**CITY OF KIRKLAND**  
**Planning and Building Department**  
123 Fifth Avenue, Kirkland, WA 98033  
425.587.3600 - [www.kirklandwa.gov](http://www.kirklandwa.gov)

## **MEMORANDUM**

**File No.:** DRV19-00138

**Subject:** KIRKLAND URBAN SOUTH  
CONCEPTUAL DESIGN CONFERENCE

DESIGN DEPARTURES

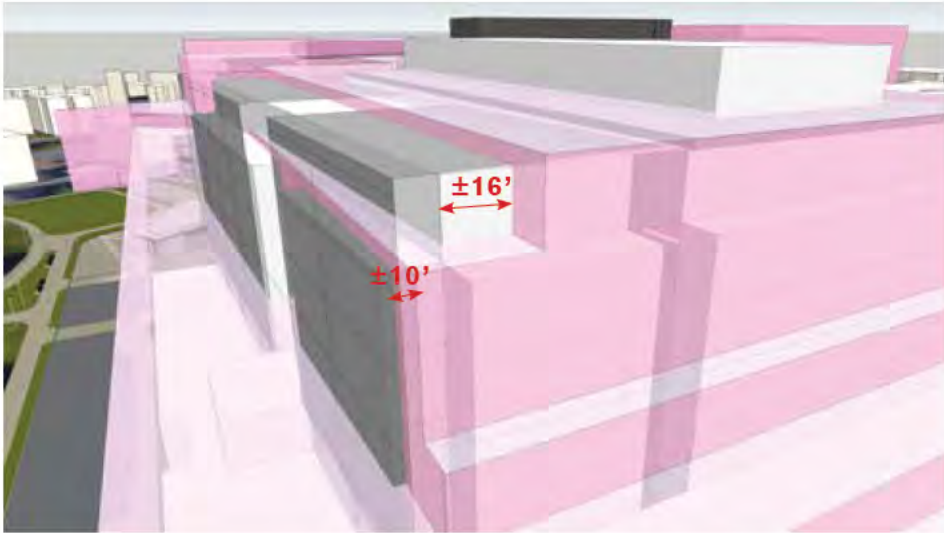
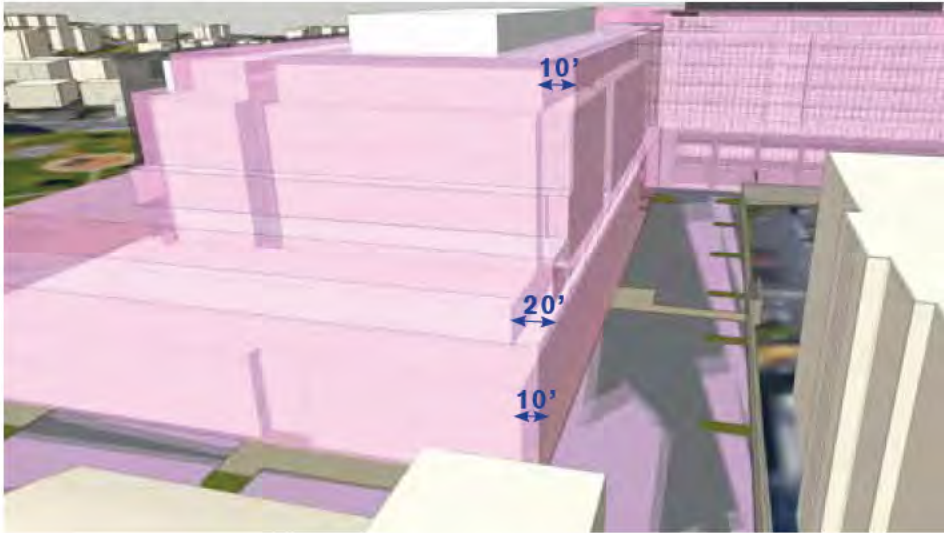
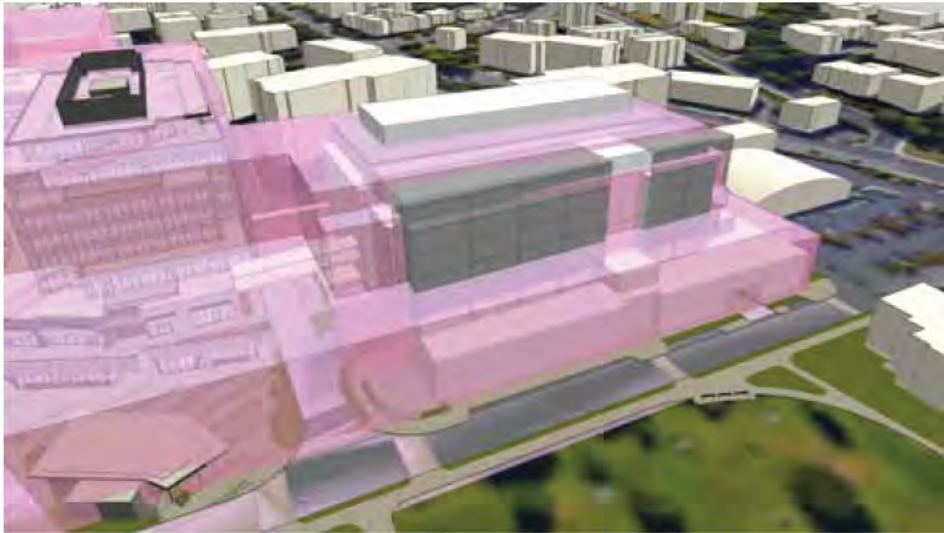
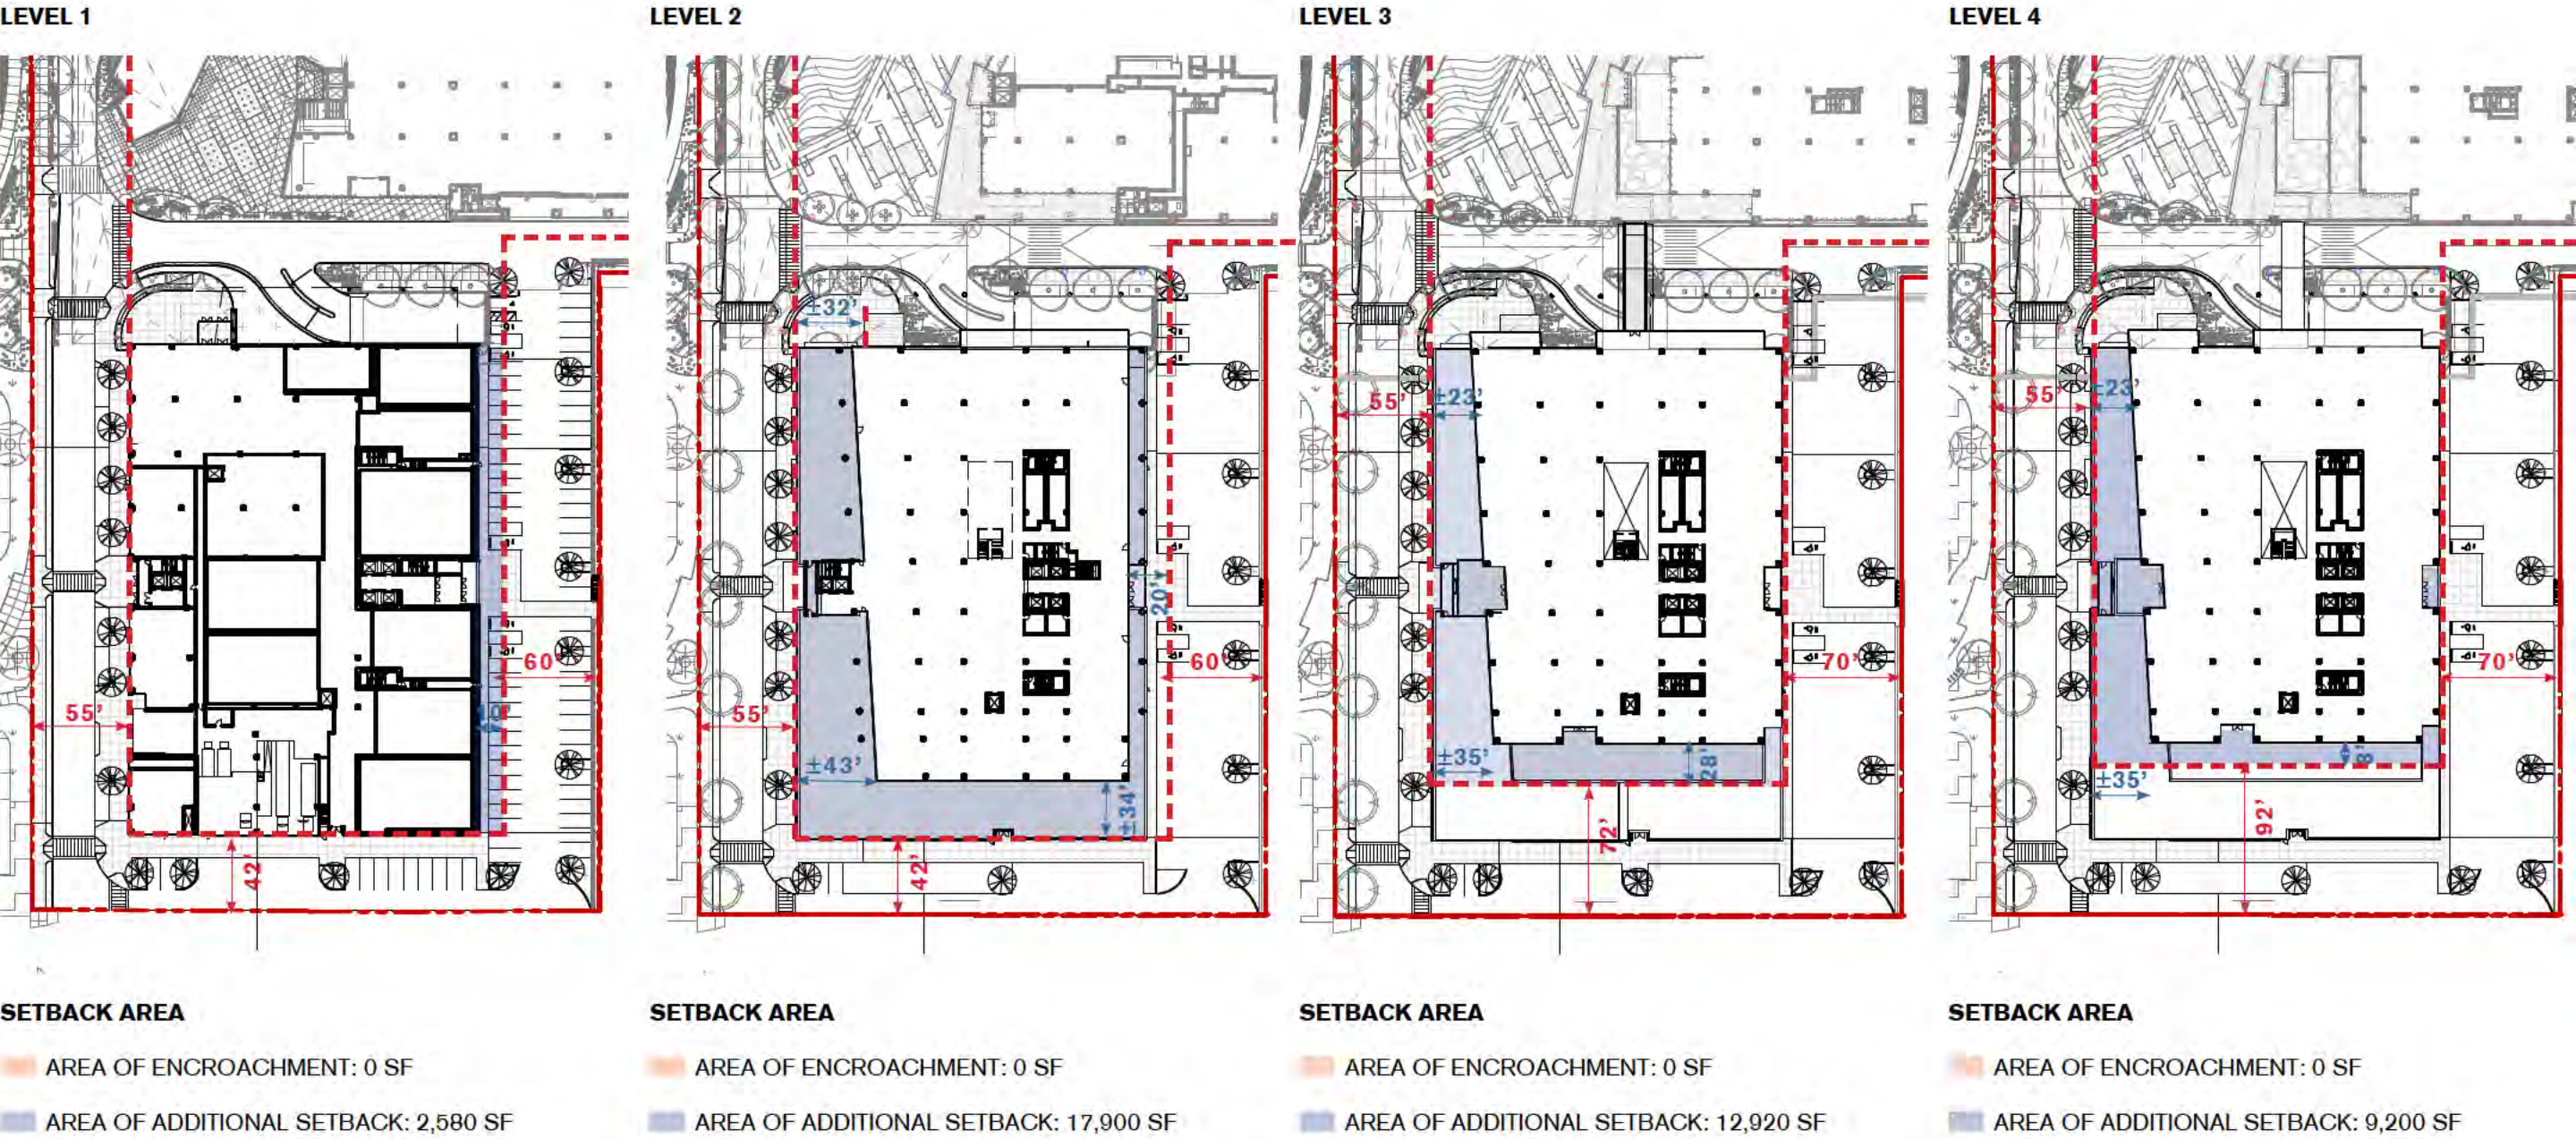
2.    Setbacks: The applicant is asking for a design departure to allow a portion of the upper floors to project into the required 100-foot and 120-foot upper story setbacks from Peter Kirk Park. Pages 2 and 46 - 48 of Attachment 1 show the design departure that is requested. The DRB has authority to grant minor variations from the minimum required yards in the CBD subject to the criteria of KZC 142.37 listed below.
